**49 CFR Parts 216 and 238  
Passenger Equipment Safety Standards;  
Final Rule**

**Passenger Equipment Safety Standards**

**ACTION:** Final rule; response to petitions for reconsideration.

**Figure 2**

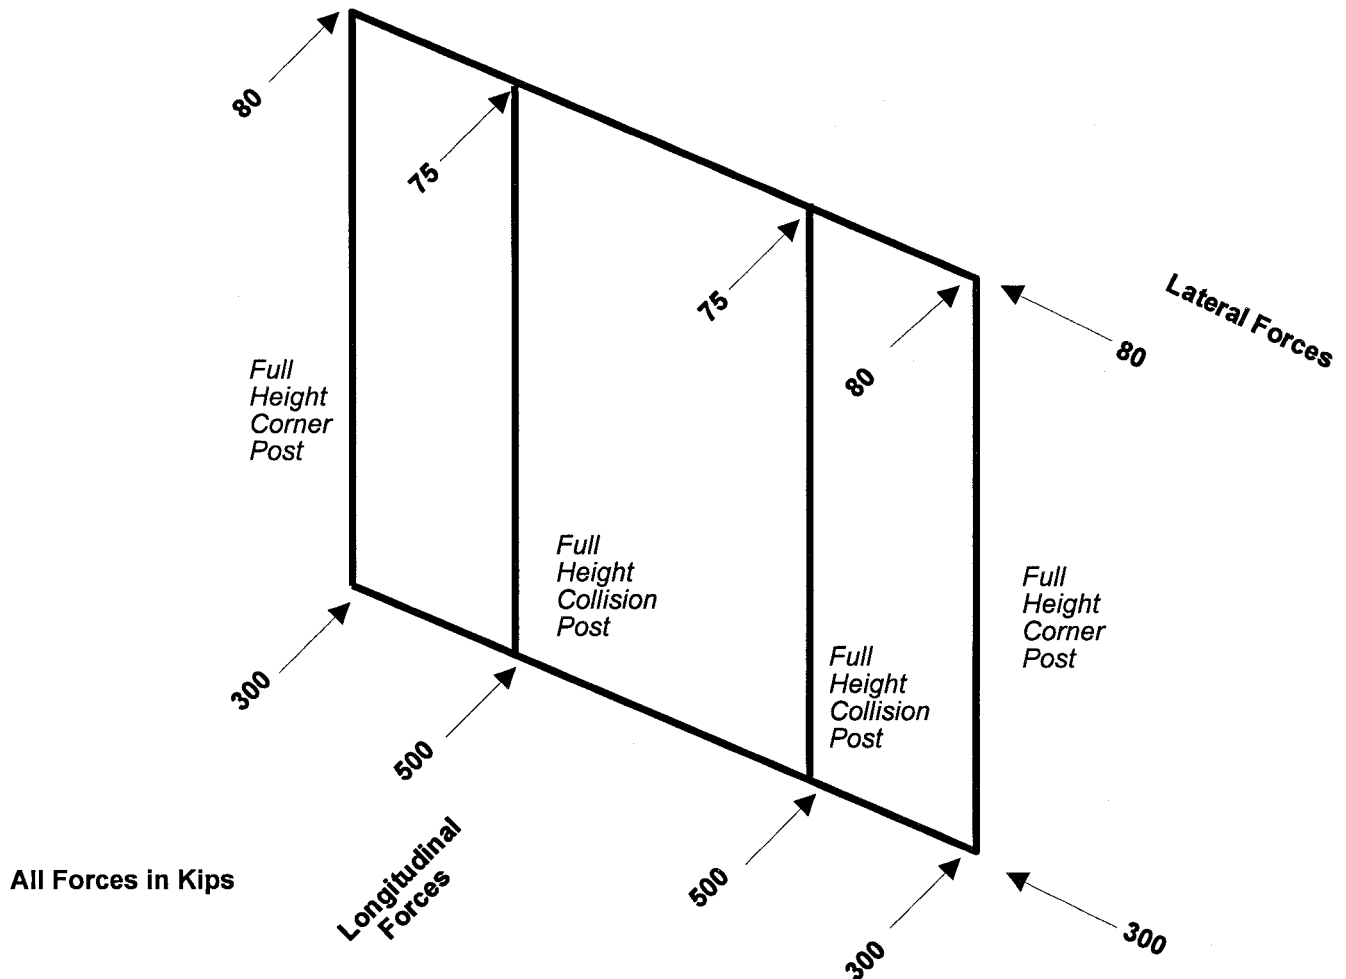
FRA has adopted Bombardier's request and modified paragraph (b)(1) accordingly. (FRA has also made a

corresponding change to figure 2 to subpart E.) FRA recognizes that the strength of the power car cab's rear collision posts should not necessarily be dependent on the strength of the cab's front end structure, as the front and rear end structures are intended to protect against somewhat different hazards. The front end structure must protect against the greater hazard of a head-on collision with another train or object.

30. Figure 2 to subpart E is revised to read as follows:
